**SUBJECT: ADDENDUM NO. 1 TO THE BIDDING DOCUMENTS
ASBESTOS ABATEMENT FOR ROCKFORD PUBLIC SCHOOLS DIST. #205
AT NASHOLD ELEMENTARY SCHOOL
BUILDING RENOVATIONS - SUMMER 2017**

**PROJECT MANUAL FOR THE ROCKFORD PUBLIC SCHOOLS
ASBESTOS ABATEMENT AT NASHOLD ELEMENTARY SCHOOL
CARNOW CONIBEAR PROJECT A139670087**

1. Environmental Scope of Work - ELIMINATION OF FLOORING ABATEMENT IN BASEMENT CAFETERIA.

ASB-0-R1

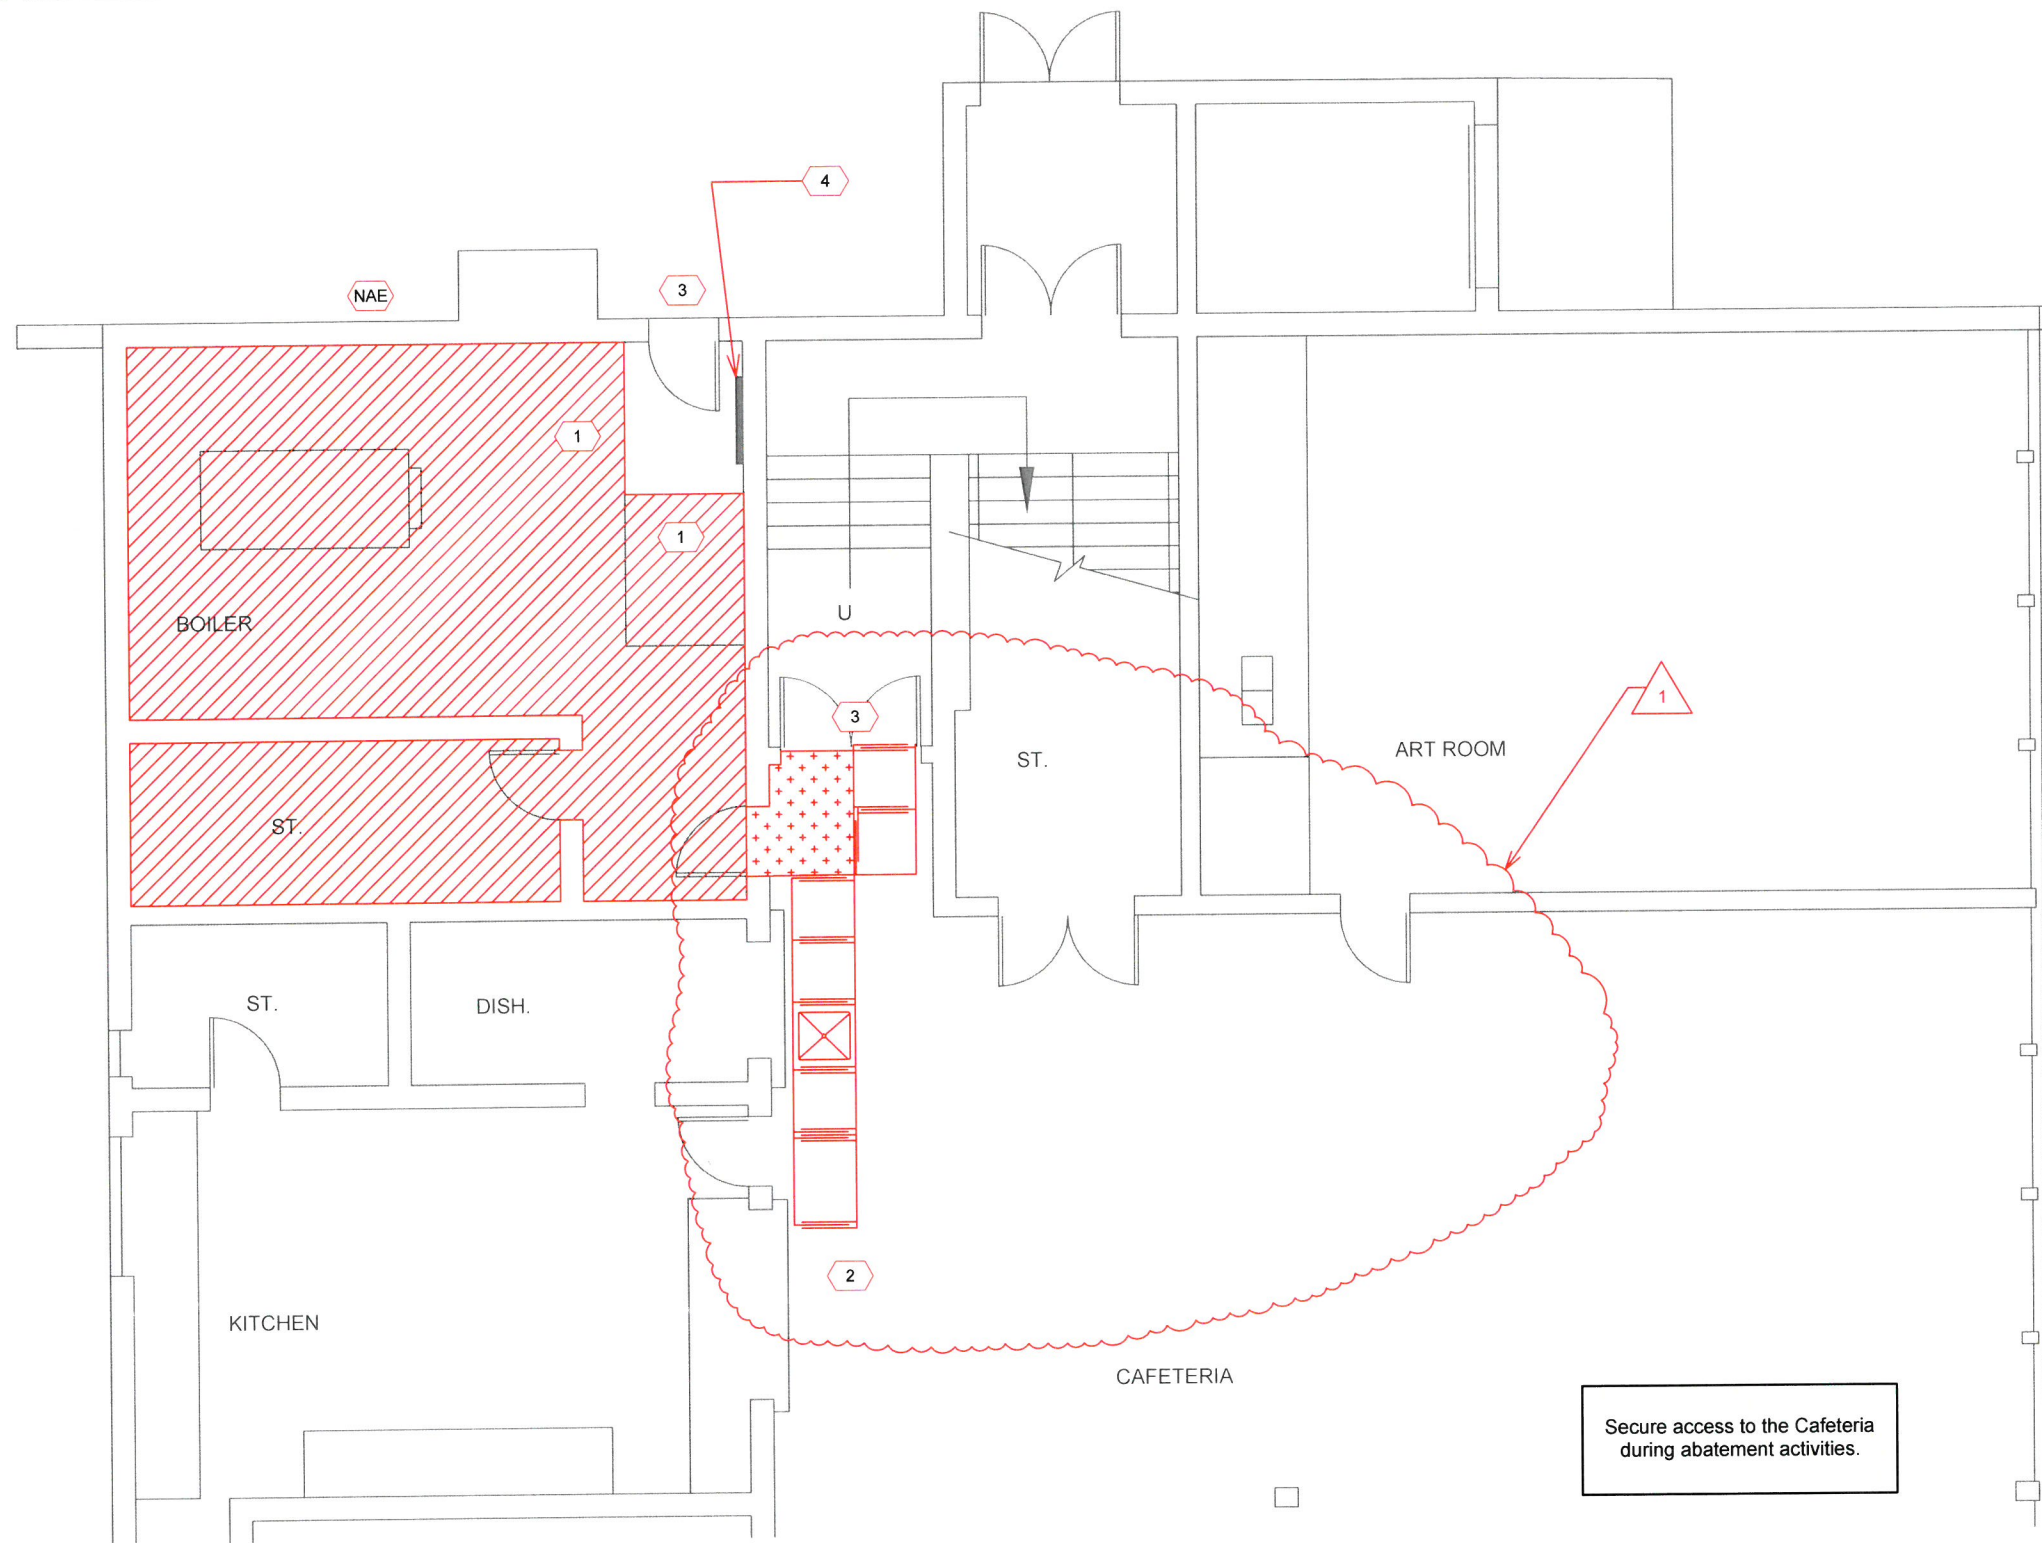
| | ADDENDUM No. 1: Work associated with the installation of the new lift has been deleted from the Scope of Work. |
